Message Ref: Amberfield project – Hamilton City Council s92 response. Terrestrial ecology.

Project No: A17134

Below is a response to the s92 further information request from Hamilton City Council (HCC) regarding terrestrial ecology. Each response is numbered following the HCC s92 Master Schedule – Category 1 document.

A17134 HAMILTON SOUTH DEVELOPMENT
Amberfield – Herpetofauna Habitat Value Map

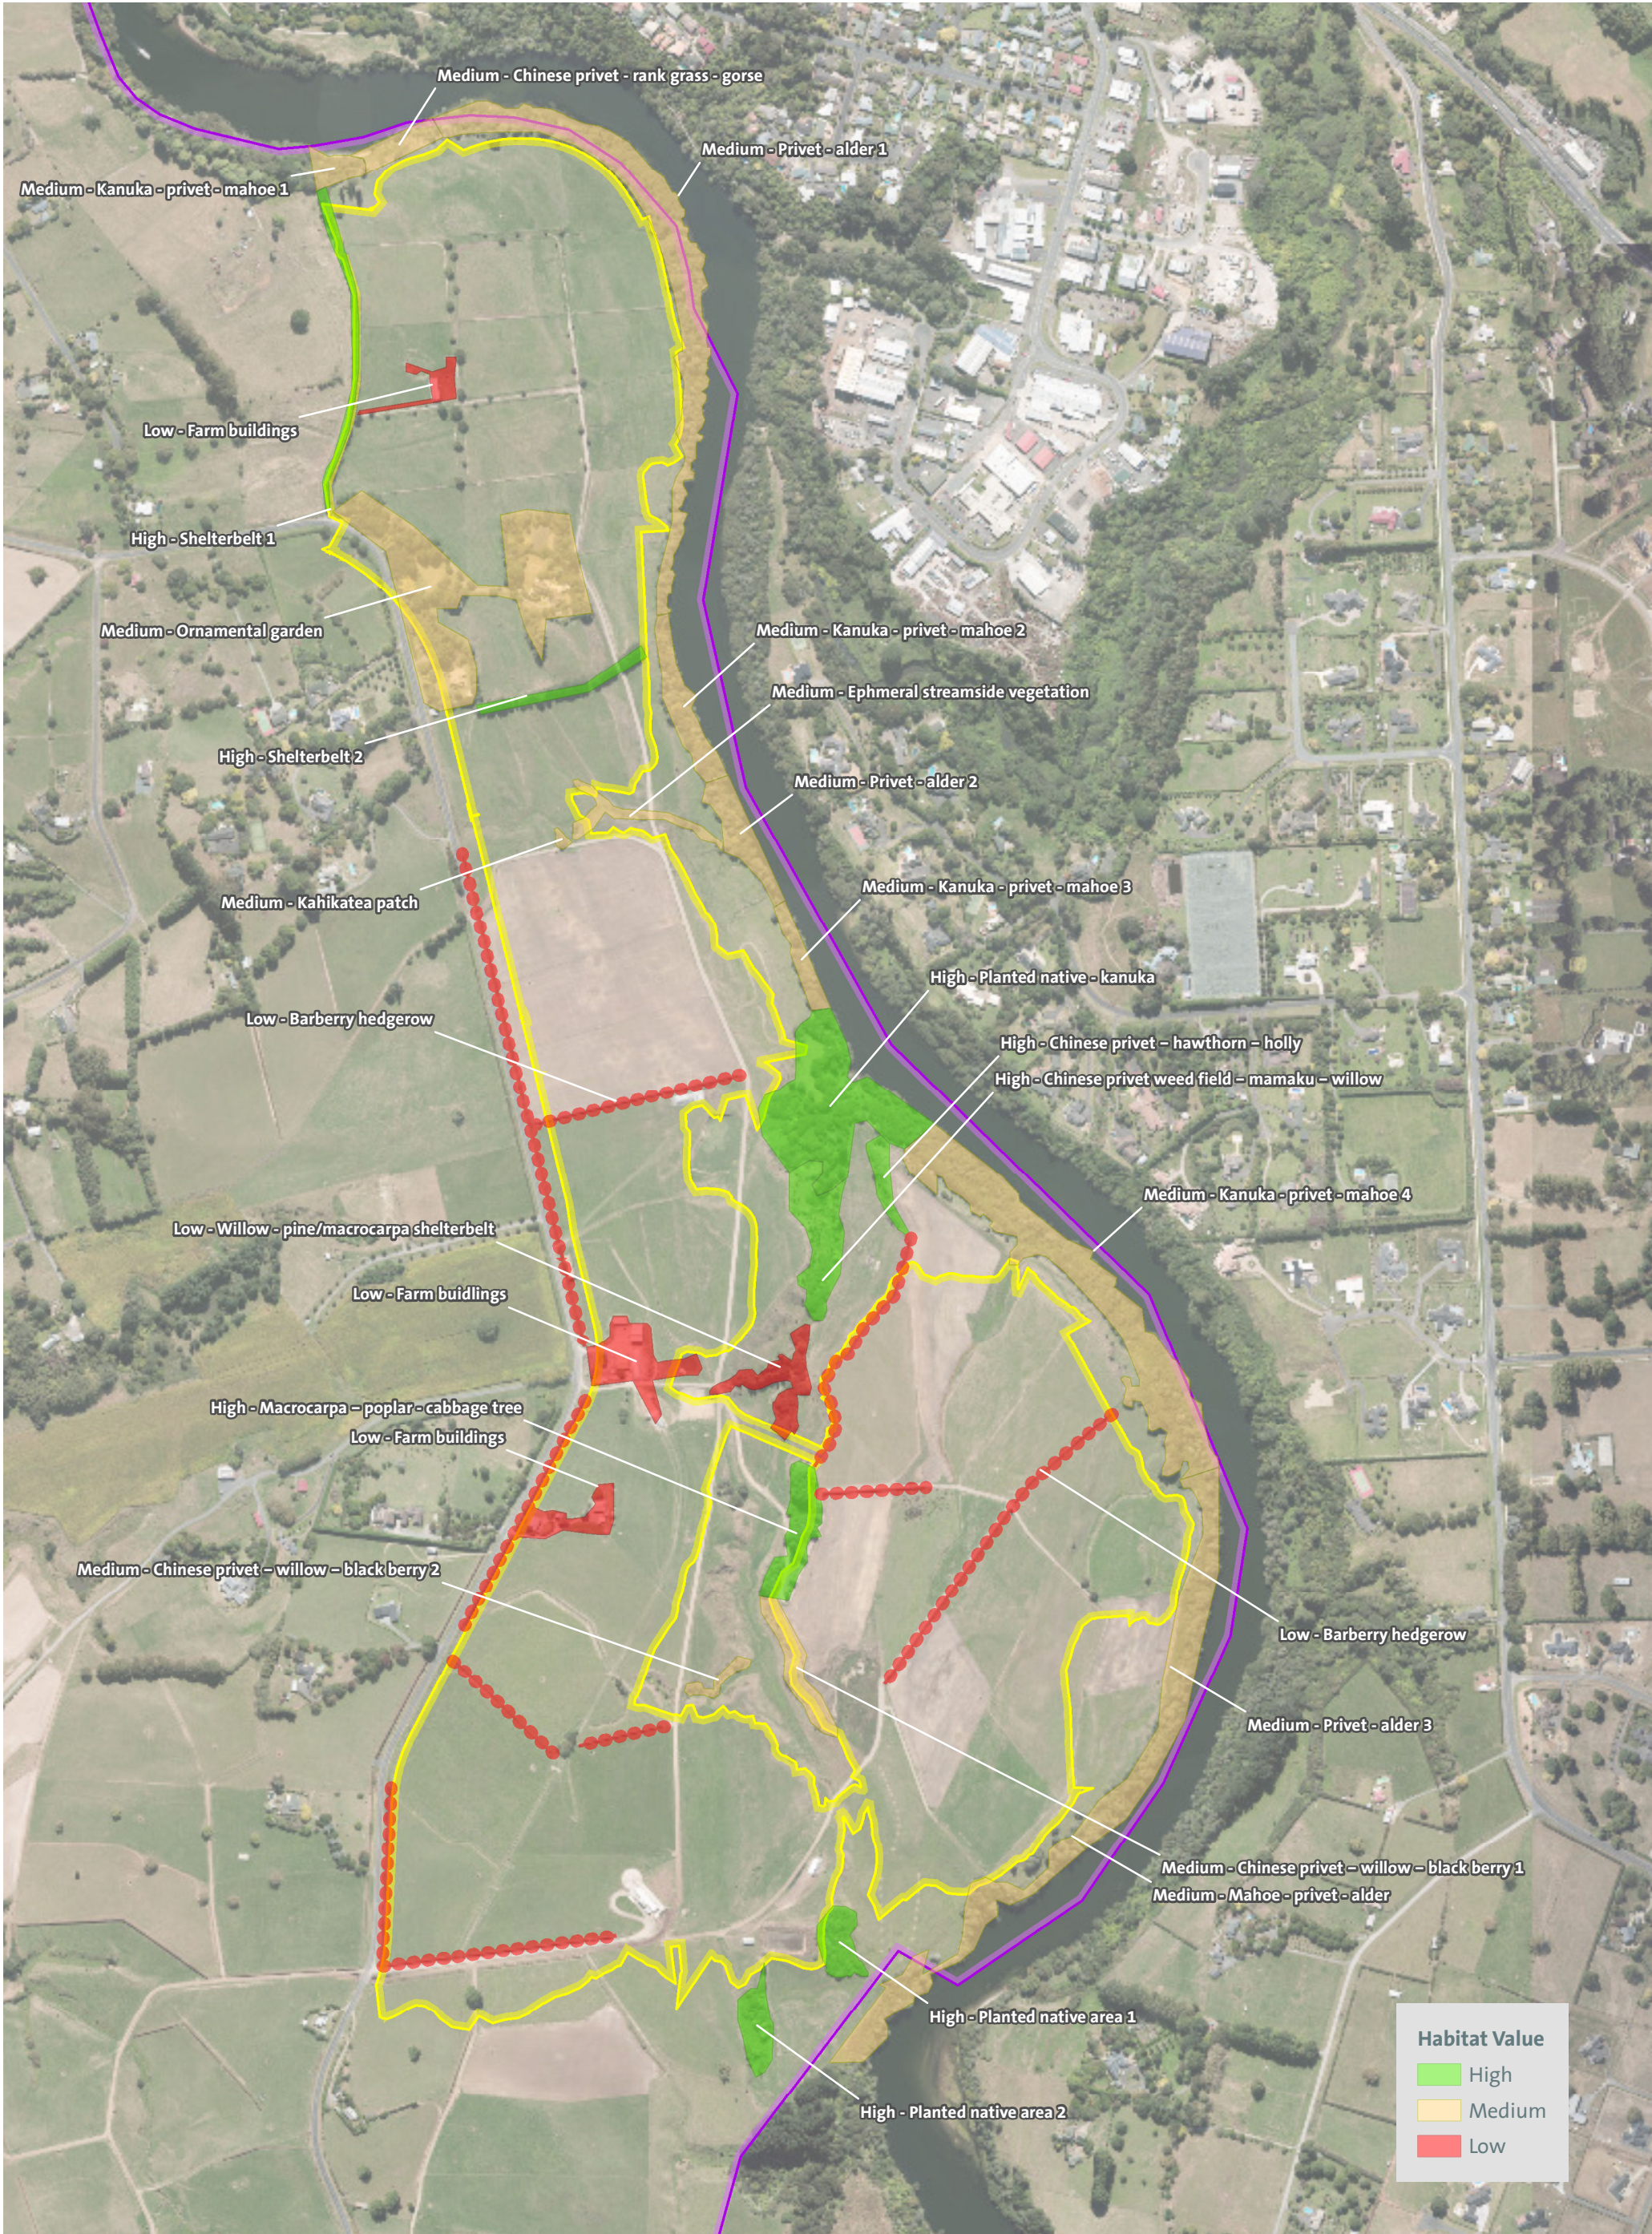
67. A map of the high, medium, and low value lizard habitat is provided in Appendix 1 of this memo. All areas not specifically mapped are areas of grazed pasture or buildings with little to no debris surrounding them and considered of negligible value. Habitat descriptions and values are consistent with Table 10 in Section 7.2 of the Terrestrial Ecological Assessment (here after referred to as “the assessment”). The development extent of the project is also shown on the map and for the purposes of the assessment it was assumed all habitat was lost within the footprint of this extent¹.

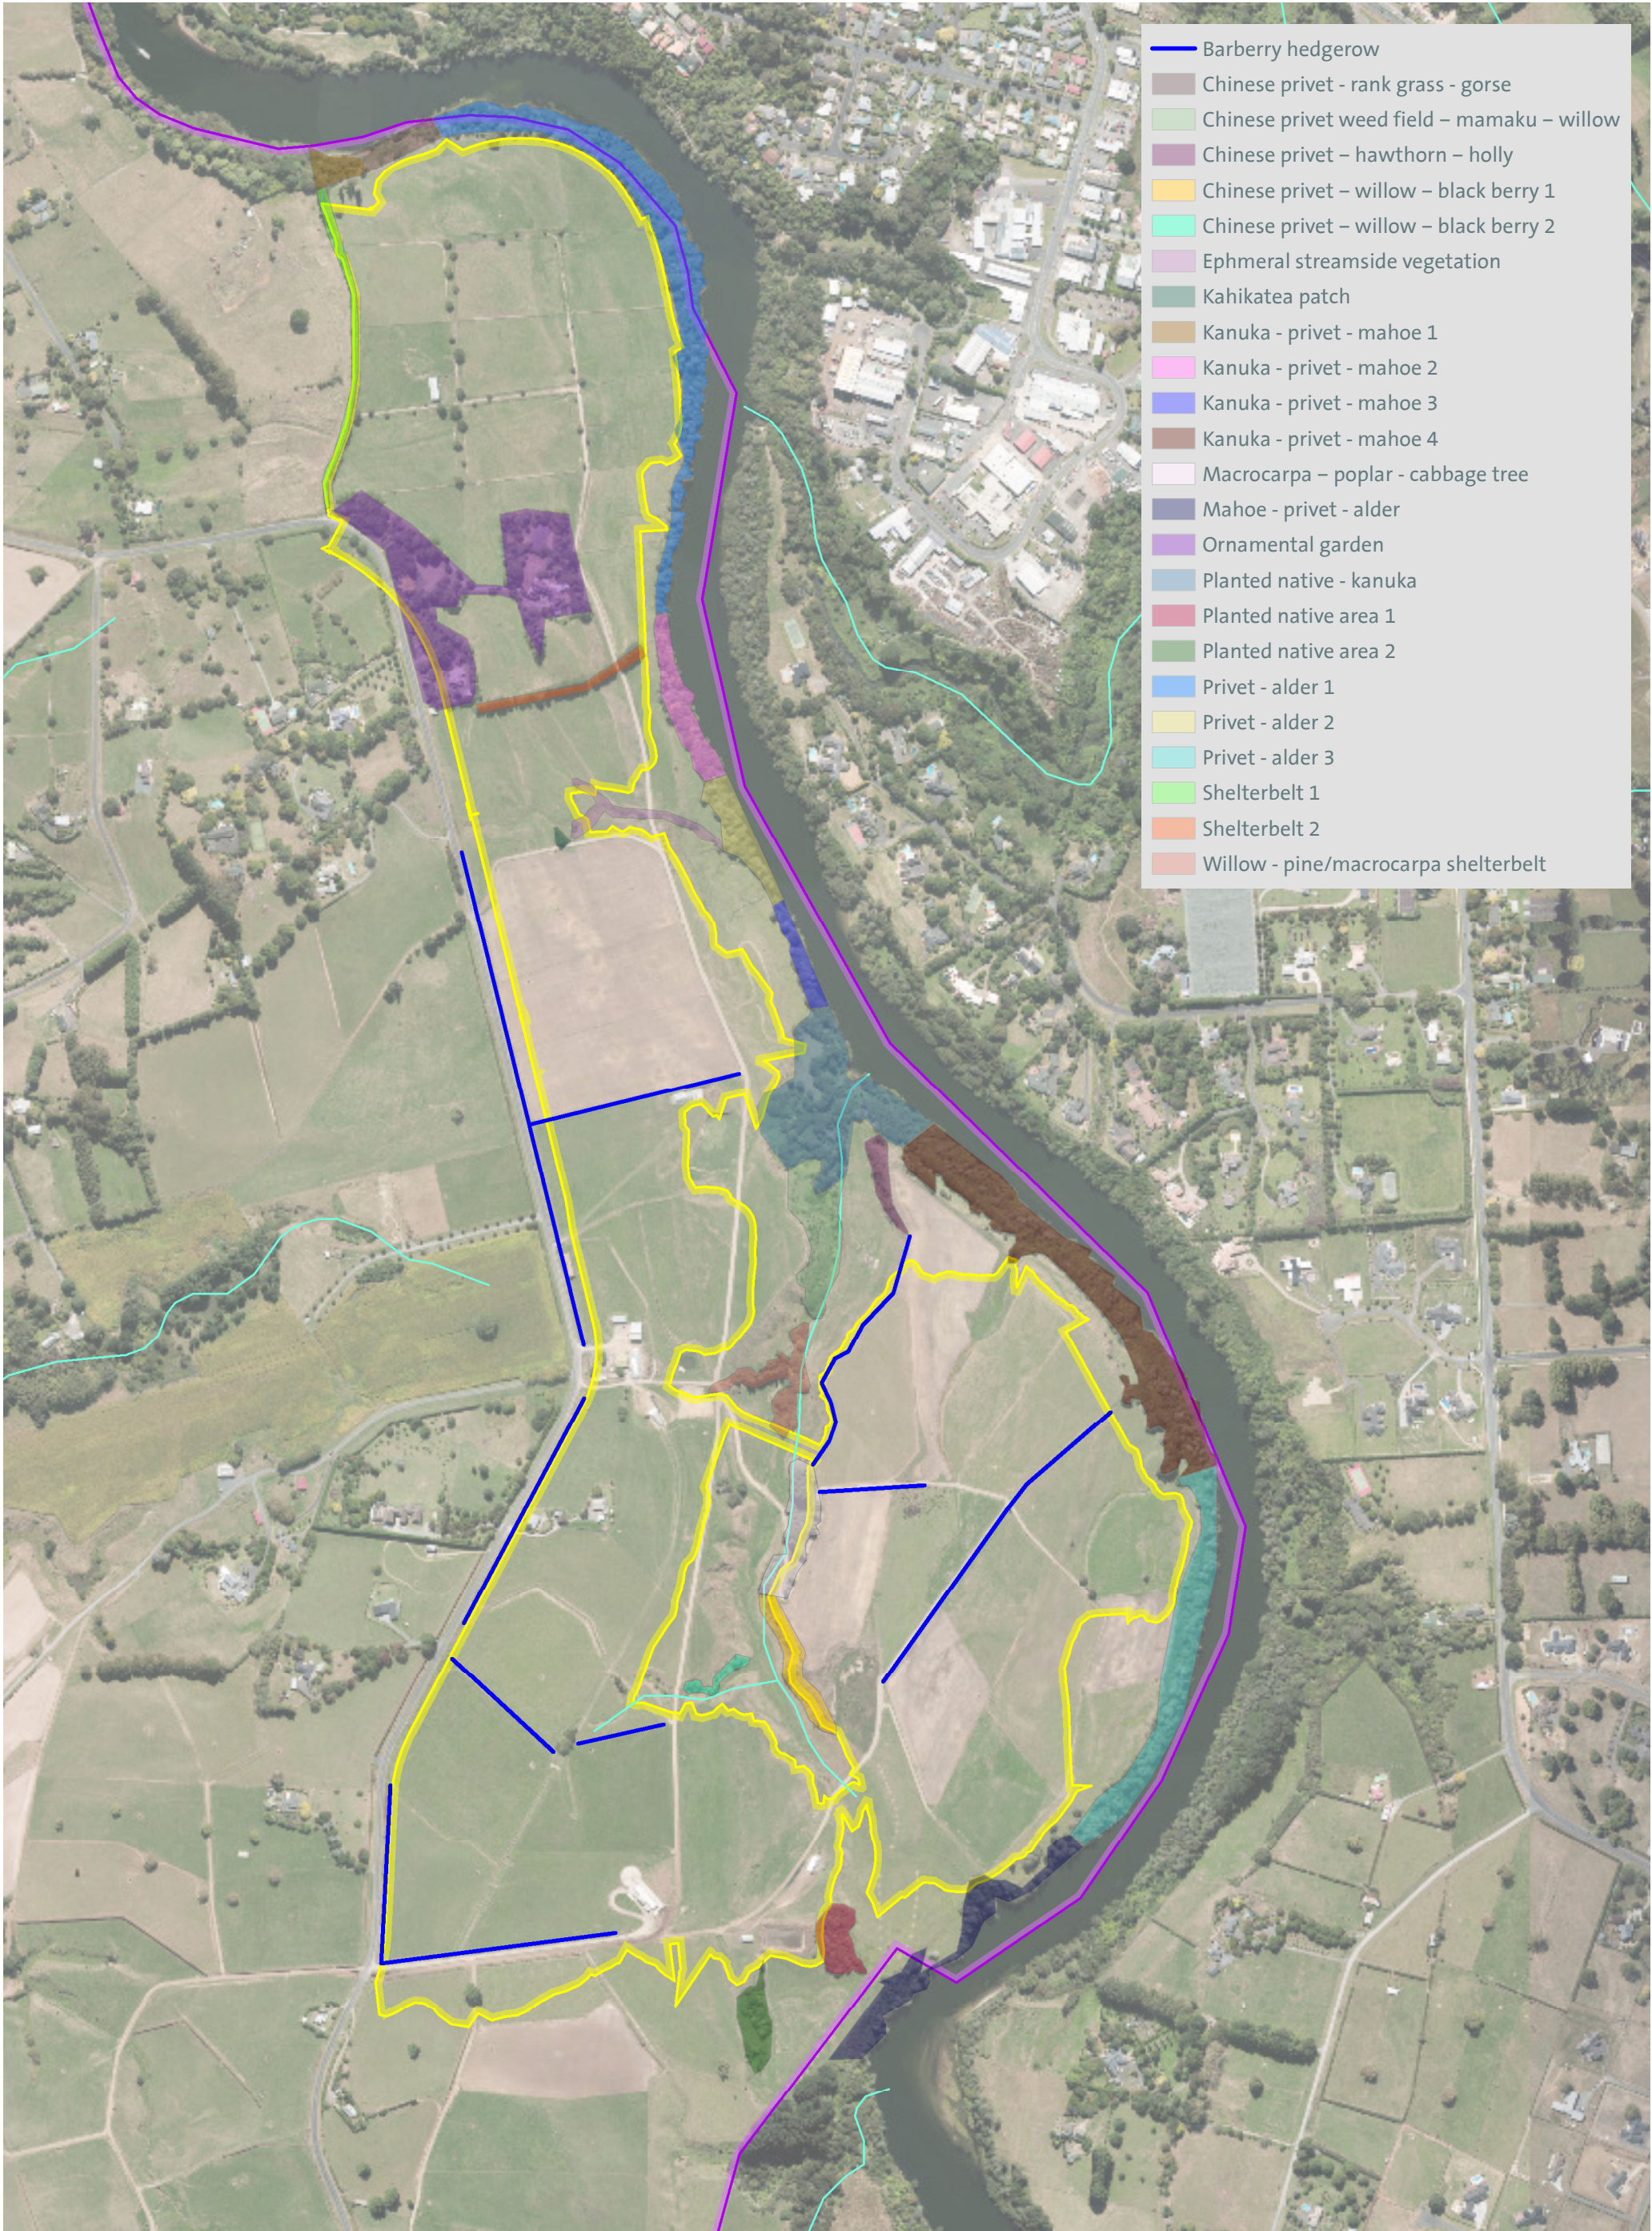
69. An updated vegetation map which includes the development extent is provided in Appendix 3 of this memo. This development extent demonstrates the setback width from existing vegetation however where the buffer width is 1m this is not easily represented at mapping scales (even blown up sections). Therefore, where mapping resolution does not allow representation of the setback a minimum of 1 m of set back from the existing riparian vegetation (as determined by the existing fence location) in the northern end of this site should be maintained for the planting of additional buffer planting at the toe of the batter slopes as per section 10.2.1.1 of the assessment. Also available in Appendix 4 is the “Gully and Esplanade Reserve

73. See Appendix 3 for detailed vegetation map with development extent. All vegetation inside the development extent is presumed to be lost.

**Gully and Esplanade
Reserve
Vegetation Strategy**

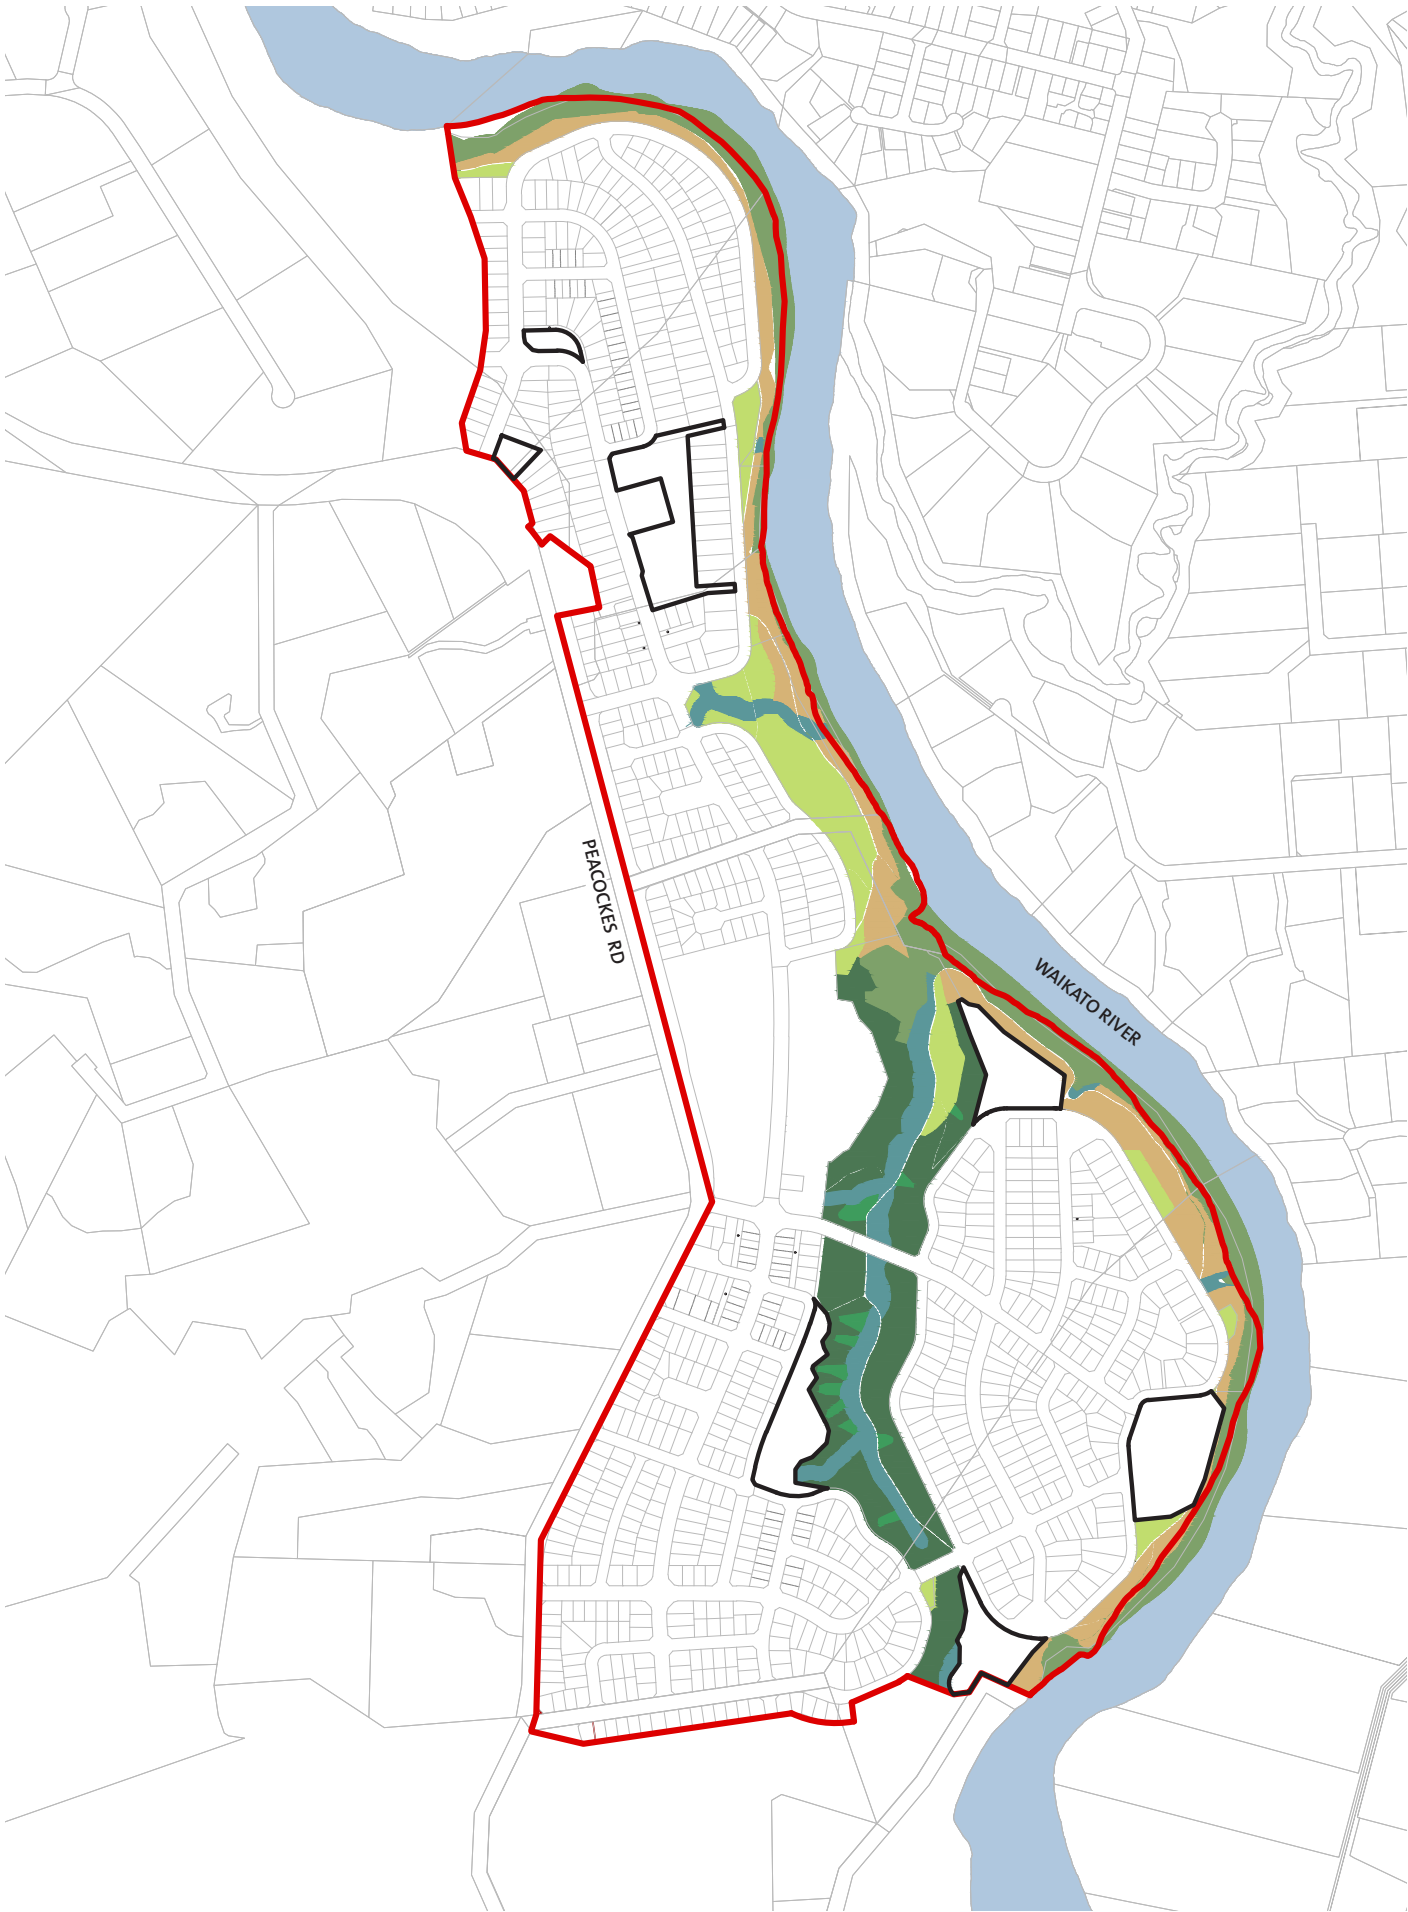
Throughout the rest of the site there are greater amounts of set-back and the riverbank vegetation contains greater density of evergreen higher stature vegetation such as *kanuka* and *mahoe*. In these areas the proposed buffer planting (Ref: Appendix 4) will act as supplement to the existing vegetation rather than as the primary buffer vegetation. Also in these areas the topology of the Waikato River will provide additional
